# **Wireless Universal Serial Bus Specification Errata on Revision 1.0 as of July, 2005**

**July, 2005**

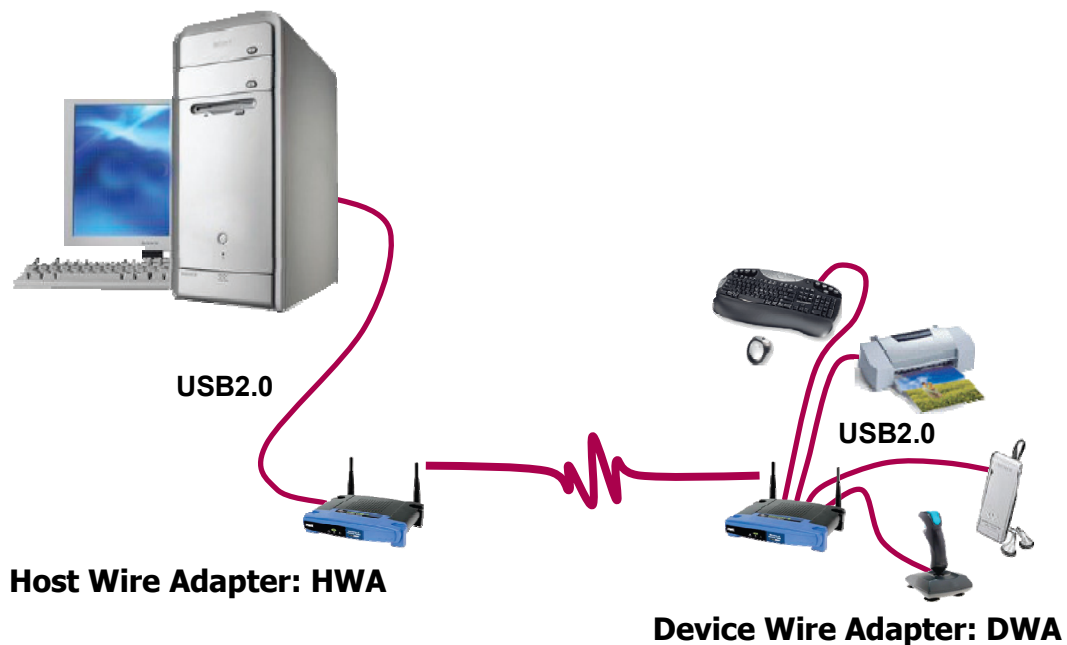
**Errata Title:** Miss-spelled word “Revsion” in section 2.3

**Change:** p10, Section 2.3, last reference must read:

[7] *WiMedia MAC Convergence Architecture Specification* (Revision 1.0). 2005. WiMedia Alliance.

**Change:** p52, Section 4.10.1, Table 4-4 should appear as follows:

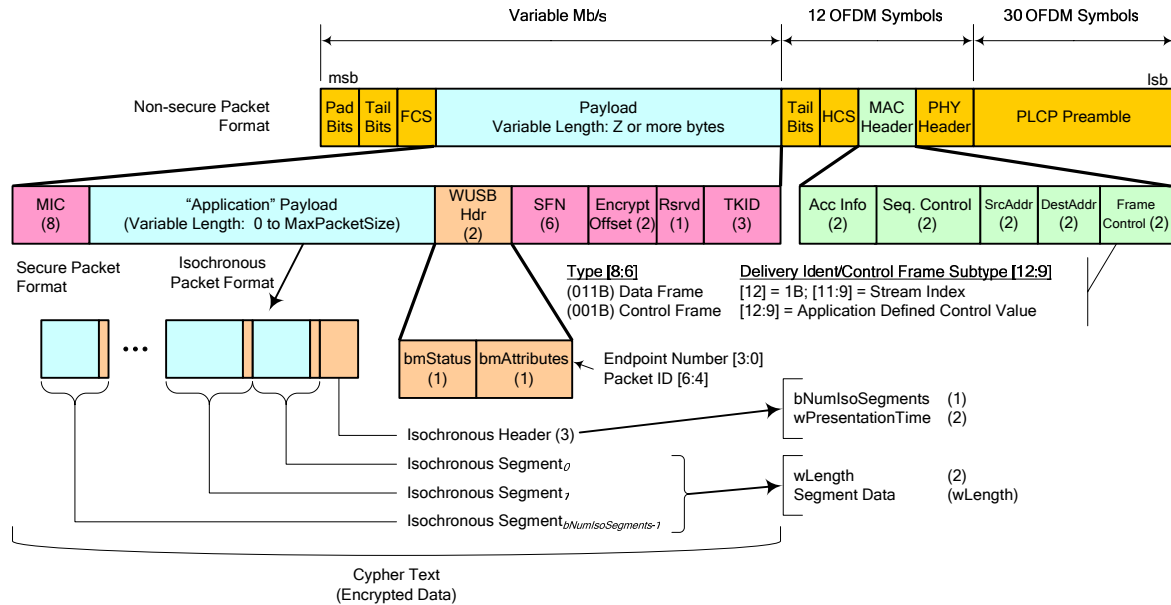
**Errata Title:** Table 4-4 does not have all the correct boxes shaded for required implementations.

**Background:** One purpose of table 4-4 is to illustrate all of the power control settings that are required to be implemented. The table as written is inconsistent and incorrect because it does not properly indicate all of the power settings that are required to be implemented by all WUSB devices.

Power Control Setting	TFI Channel Power Level		FFI Channel Power Level	
	Nominal values	Accuracy requirement	Nominal values	Accuracy requirement
0	TFI_BASE	TFI_BASE	FFI_BASE	FFI_BASE
1	TFI_BASE – 2 dB	TFI_BASE – (1 to 3) dB	FFI_BASE – 2 dB	FFI_BASE – (1 to 3) dB
2	TFI_BASE – 4 dB	TFI_BASE – (3 to 5) dB	FFI_BASE – 4 dB	FFI_BASE – (3 to 5) dB
3	TFI_BASE – 6 dB	TFI_BASE – (4.8 to 7.2) dB	FFI_BASE – 6 dB	FFI_BASE – (4.8 to 7.2) dB
4	TFI_BASE – 8 dB	TFI_BASE – (6.4 to 9.6) dB	FFI_BASE – 8 dB	FFI_BASE – (6.4 to 9.6) dB
5	TFI_BASE – 10 dB	TFI_BASE – (8 to 12) dB	FFI_BASE – 10 dB	FFI_BASE – (8 to 12) dB
6	TFI_BASE – 12 dB	TFI_BASE – (9.6 to 14.4) dB	FFI_BASE – 12 dB	FFI_BASE – (9.6 to 14.4) dB
7	TFI_BASE _ 14 dB	TFI_BASE – (11.2 to 16.8) dB	FFI_BASE – 14 dB	FFI_BASE – (11.2 to 16.8) dB
